SERVICE BULLETIN

APPLICABILITY: 2020-24MY Legacy & Outback
2019-25MY Ascent

NUMBER: 12-267-25

SUBJECT: Hood Lock Assembly / Design Change

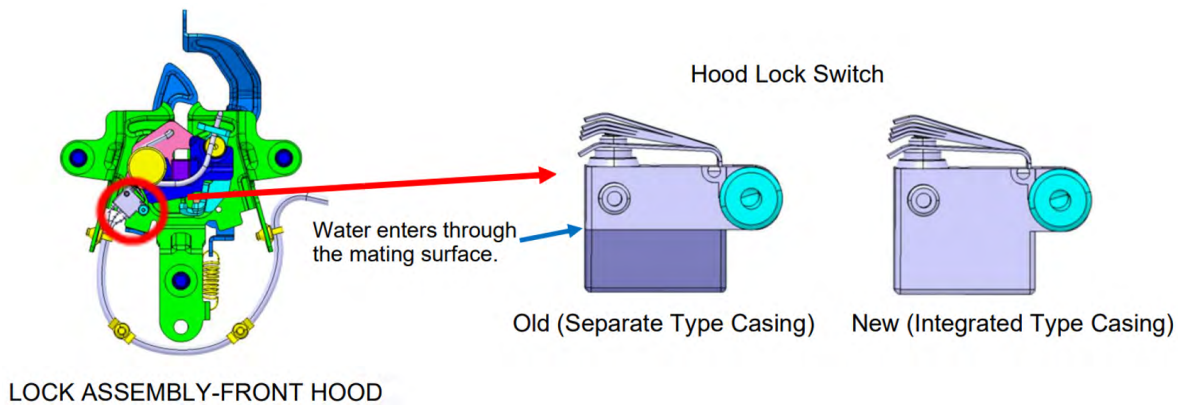
This bulletin announces a design change to the hood lock switch portion of the hood lock assembly. The new hood latch switch is a one-piece design, optimizing its waterproof characteristics. This has been developed to address customers' concerns of the instrument cluster giving a false indication of the hood being ajar, a flashing Auto Start Stop warning light and customers being unable to remote start their vehicle. If any of these conditions are verified, perform testing of the hood latch switch and replace it if found to be defective.

The new hood lock assembly has been incorporated into vehicle production as per the table below.

Model	Starting VIN
Legacy	R3023093
Outback	R3245239
Ascent	S3413773
